B. [PLANNED UNIT DEVELOPMENT 1, 2024, INCLUDING SITE PLAN 54-7-2024](#)

PROPOSAL: Construction of gasoline service station with drive-through restaurant within RC-2, Multiple-Family Residential District

Case: PUD 1, 2024, including site plan 54-7-2024
Site: 27815 and 28025 Middlebelt Road
(Parcels 23-11-477-109, 23-11-477-013, and 23-11-477-014)
Applicant: SkilkenGold Real Estate Development
Application Date: May 15, 2024 (Final PUD Plans- July 16, 2024)
Zoning: RC-2 Multiple Family Residential District

DATE: August 5, 2024
TO: Planning Commission
FROM: James Cubera, City Engineer 
SUBJECT: PUD 2-2024
Sheetz
PJ #11-24-90
27815 & 28025 Middlebelt
22-23-11-477-109 &013

KIMLEY-HORN OF MICHIGAN, INC. 2000 SOUTHFIELD AVENUE, SUITE 400 SOUTHFIELD, MI 48075 WWW.KIMLEY-HORN.COM	 TYLER SMITH ENGINEER No. 6201068975
	PRELIMINARY UTILITY PLAN
SHEETZ - 12 MILE AND MIDDLEBELT	
ORIGINAL ISSUE: 07/16/2024 KHA PROJECT NO. 268593001 SHEET NUMBER C3.0

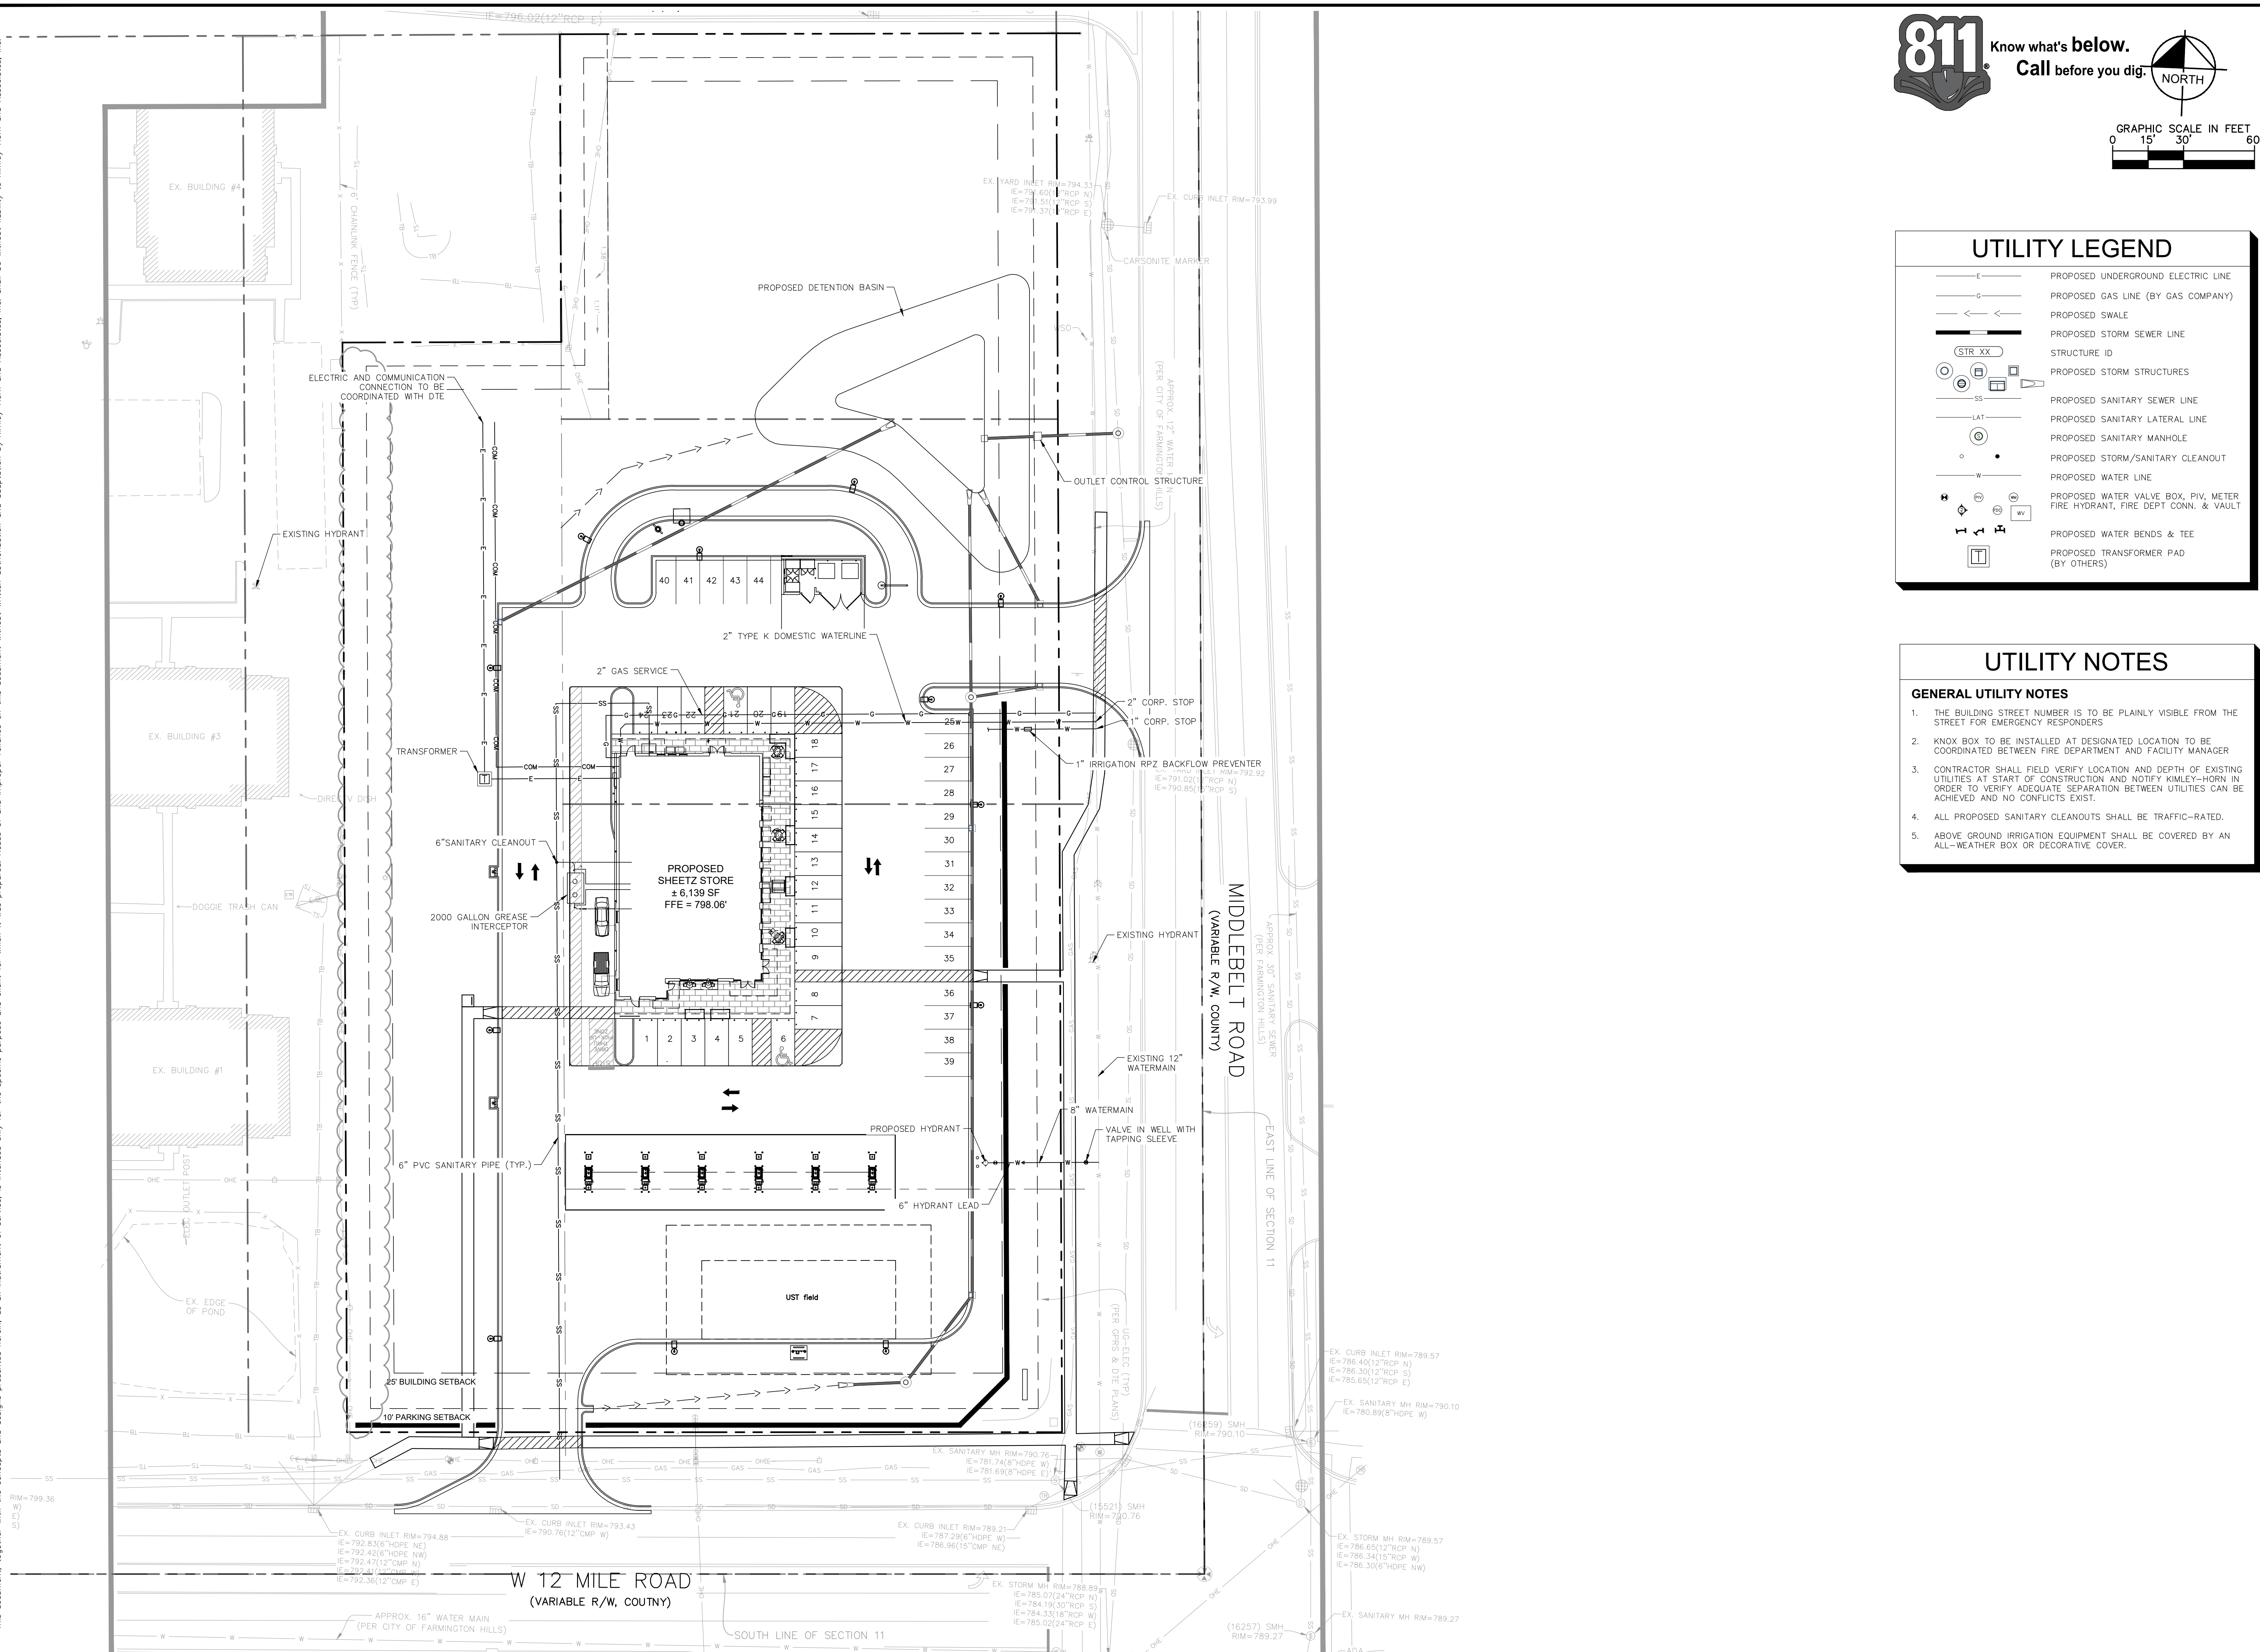
1. A 16-inch water main exists along the south side of 12 Mile Road across the frontage of this site. In addition, a 12-inch water main exists along the west side of Middlebelt Road across the frontage of this site. Both lines are available for service. We note that the plans do not identify the onsite watermain. This needs to be provided for review.

2. An 8-inch sanitary sewer exists along the north side of 12 Mile Road across the frontage of this site. It is available for service. The plans do not identify the onsite sanitary sewer. If the existing sanitary sewer lead is being considered for re-use it must be televised and any infiltration/inflow issues or deficiencies must be corrected.

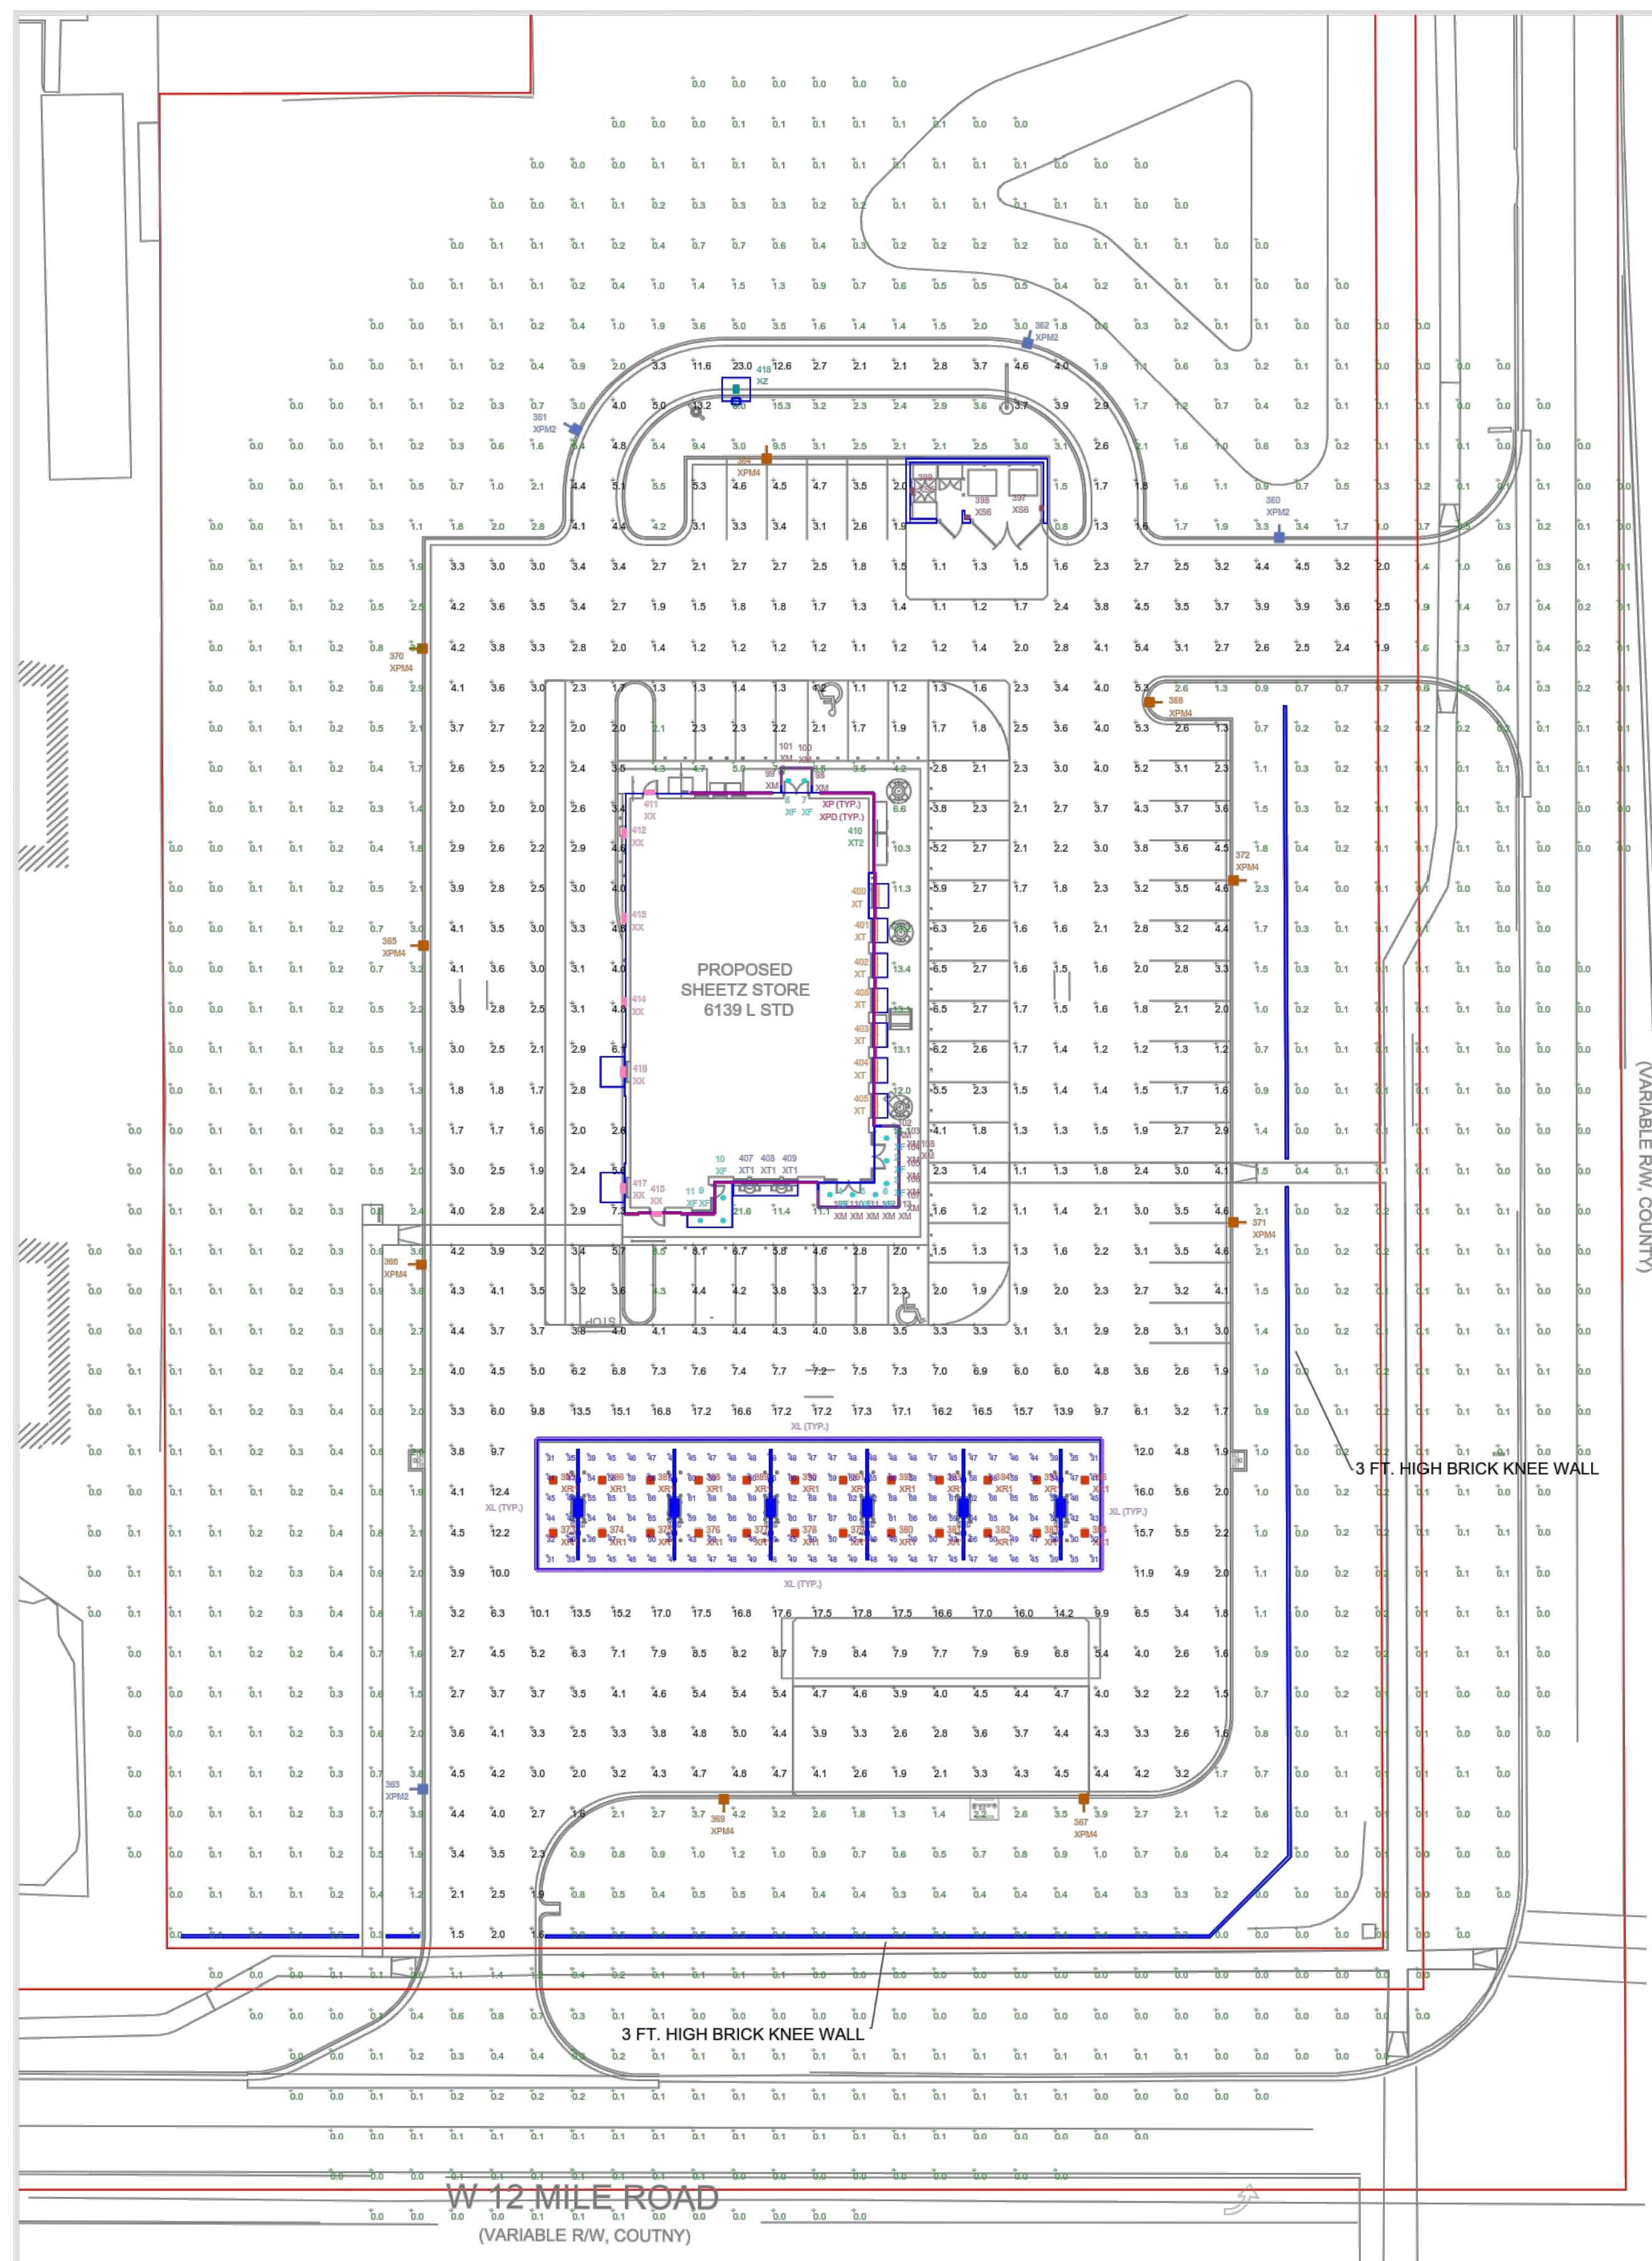
The ordinance prohibits fixtures upon the sides of canopies. **Lighting appears noncompliant with this standard, but relief may be granted by the planning commission.** *Fixture details for strip lighting fixtures identified as XL were not provided. The applicant shall clarify whether strip lighting will be exposed or under the canopy. The planning commission shall consider whether the 5% tilt, due to the tilt of the canopy, is acceptable.*

The proposed lighting meets the average to minimum ratio of 4:1. However, the proposed lighting exceeds the requirement limiting illumination to .3 footcandles at the property line. **Excess lighting is proposed near driveways. Such lighting may be permitted by the Planning Commission when deemed necessary for public safety.**

The lighting illumination is limited to 1.25 lumens per sf of hard scaped area and 1,000 lumens per door in residential districts. All other districts have up to 2.5 lumens per sf of hardscape area and 2,000 lumens per door. *The plans provided do not include sufficient information to determine compliance with this standard, however, since standards are intended to apply to residential districts, it is likely that the applicant will need relief from this provision.*
